Modification to Approved Project
City of Rochester, New Hampshire

Re: Residential Site Plan Modifications; Easter Seals New Hampshire; 215 Rochester Hill Road, Map 243, Lots 39.

Project name Champlin Place – Easter Seals NH Senior Housing Project

Case # 243-39-A-21

UTILITY PLAN
TAX MAP 243, LOT 39
215 ROCHESTER HILL RD
ROCHESTER, NH
PREPARED FOR:
EASTER SEALS NH, INC.
MARCH 11, 2022

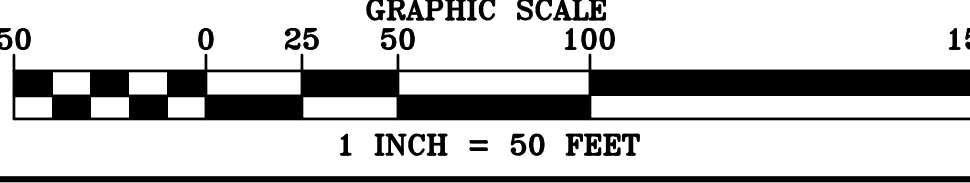
Recently, Eversource informed the applicant that they would not allow the approved underground power conduits to be placed across the open field and that they would need to be placed near a roadway or driveway. Please refer to the attached Utility Plan with the originally designed underground utilities are in "Red". They stated that they require all-season access to the wires, which would not be the case if the underground wires are placed in the open field. They suggested placing the conduits near or under the existing driveway from Route 108 to the proposed pad mounted transformer by the proposed building.

This suggestion by Eversource would require trenching very close to the 6 very large Linden trees that flank the existing driveway. The trenching would have a significant impact to the tree root system that would likely result in killing the trees in only a couple years. When our concerns about the trees and additional cost to reconstructing the paved driveway was discussed with Eversource, they suggested that wires be run overhead from the street to a new utility pole be placed just after the last tree, and then run the conduits underground the rest of the way to the transformer. Since the first section, approximately 135 feet will be overhead, a waiver is hereby requested to allow for an overhead wires in lieu underground.

In addition to the change from the street to the proposed transformer, Eversource is also requiring a new service be run to the existing Homemakers Health Service building (formally the Champlin residence) and then looped around to the existing transformer located on Healthcare Drive. At which point, the old underground utilities across the field that use to service the Homemakers Health Services will be disconnected and abandoned. The proposed relocation of the utilities are depicted on the Utility Plan in "Blue".

Reason/justification(s) for waiver request Eversource will not allow the underground utilities to be located in the open field and away from a year-round accessible route, such as driveway for this facility. As such, placing the utilities underground and near the paved driveway would result in serious damage to the mature tree roots to the row of Linden trees that flank the driveway. Thus, the proposal is to run overhead past the trees to a new pole, then underground from that point to the buildings.
